THM 4T40-E TRANSAXLE CASE, CHANNEL PLATE AND CHECKBALL LOCATION CHANGES FOR 1997

Figure 2
AUTOMATIC TRANSMISSION SERVICE GROUP

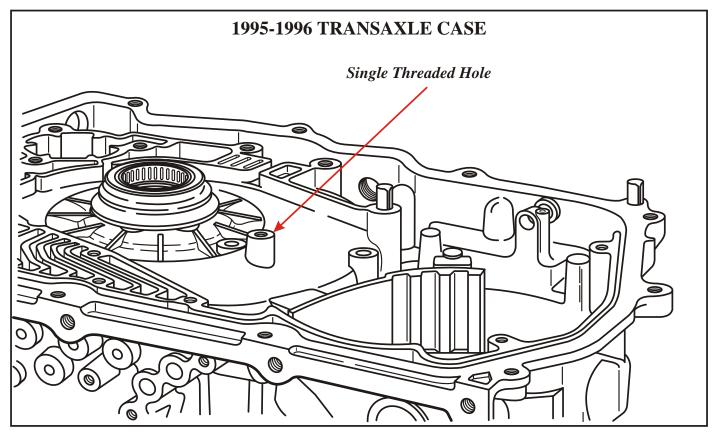
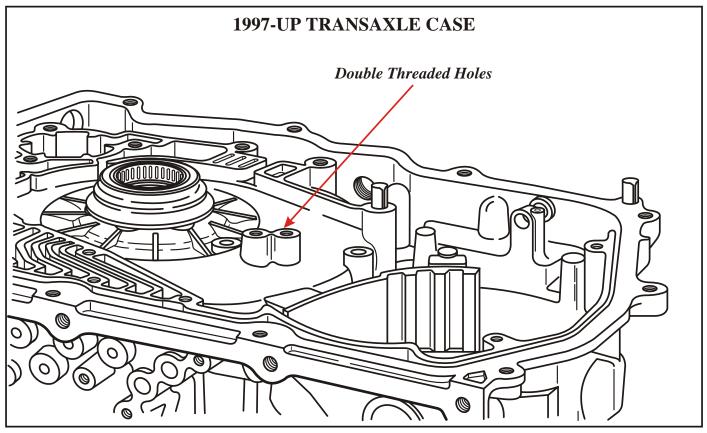
- (1) TRANSAXLE CASE Added boss and the second threaded hole to the case in the area shown in Figure 2, to accommodate valve body bolt and channel plate changes for improved clamping. The previous design case, with the single boss and hole is shown in Figure 1.

Figure 4

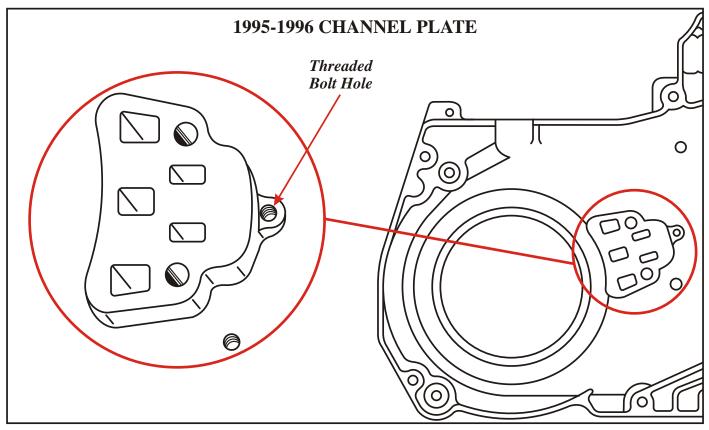
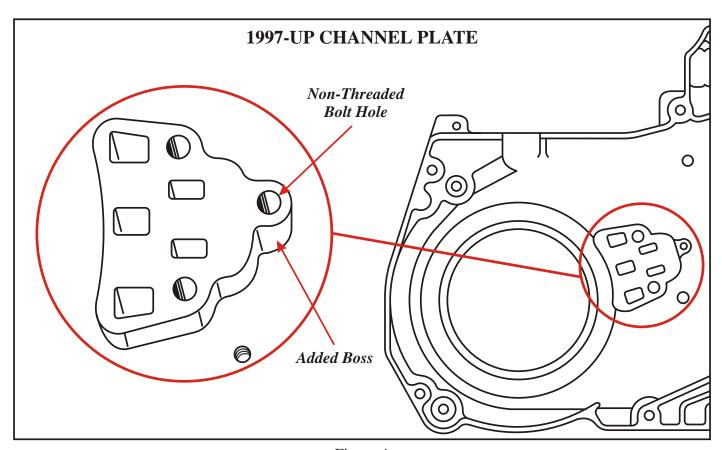
- (2) CHANNEL PLATE New casting with an added boss, and one of the threaded holes in the channel plate changes to a non-threaded hole to accommodate the valve body bolt changes for improved clamping force. The previous design channel plate is shown in Figure 3, and the new design channel plate is shown in Figure 4.

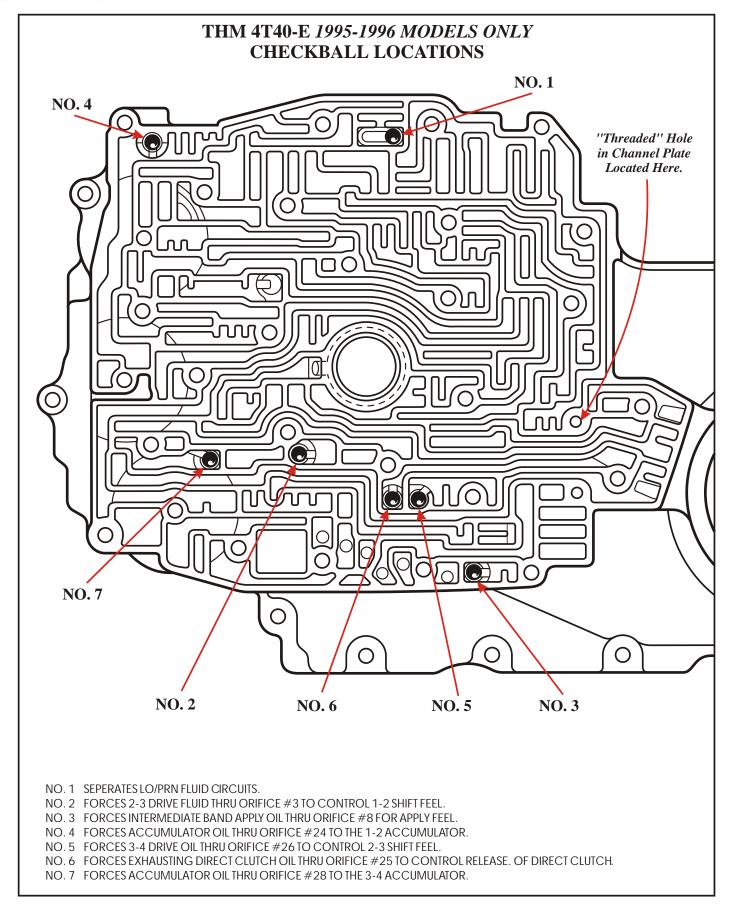
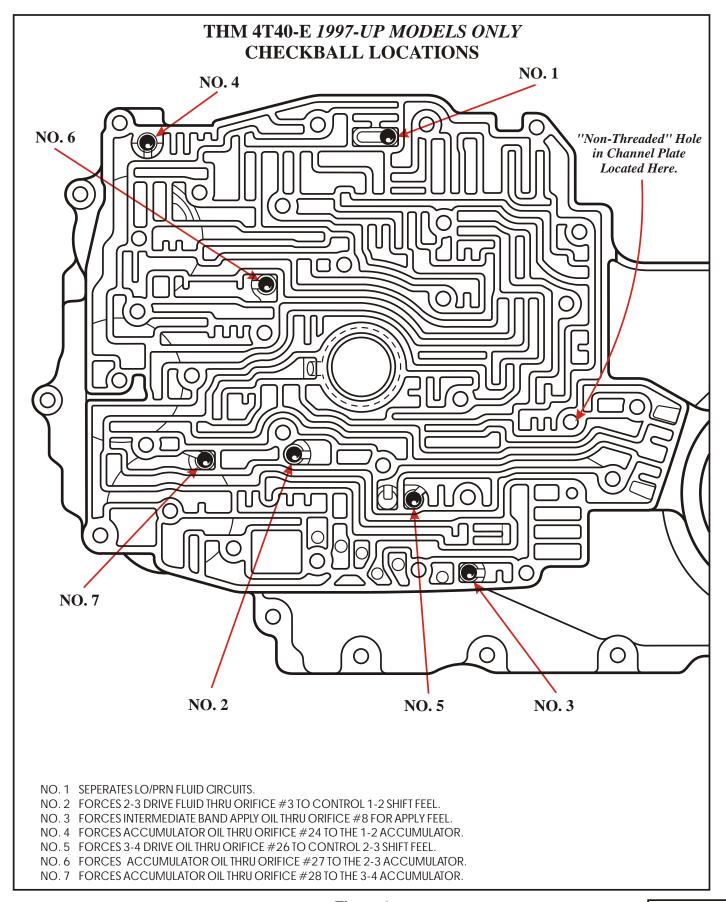
- (3) CHECKBALL LOCATIONS The number 6 checkball moves from the direct clutch apply circuit, and into the 2-3 accumulator circuit. There were no changes in worm track configuration, however we also show the "Threaded" hole that changed to a "Non-Threaded" hole in the channel plate. Refer to Figure 5 for 1995-1996 checkball locations, and Figure 6 for the 1997-Up checkball locations.

Figure 7
AUTOMATIC TRANSMISSION SERVICE GROUP

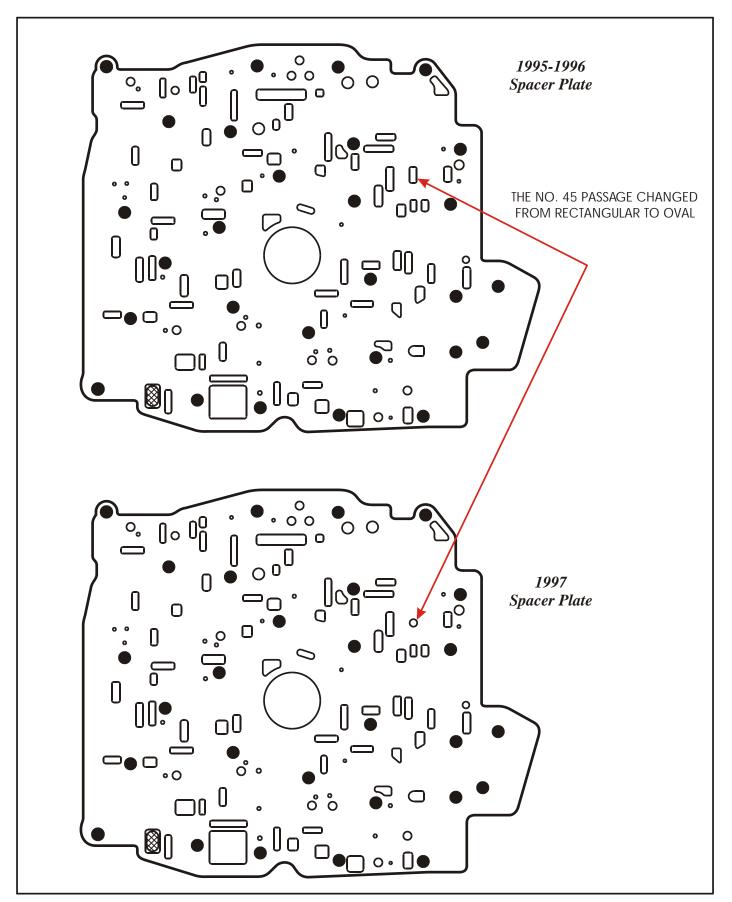
- (4) SPACER PLATE The number 45 exhaust passage in the spacer plate has changed from a rectangular hole to a small oval hole, as shown in Figure 7.
- (5) DRIVEN SPROCKET SUPPORT Ball capsule added in the direct clutch circuit to act as an air bleed to improve direct clutch apply, as shown in Figure 8.
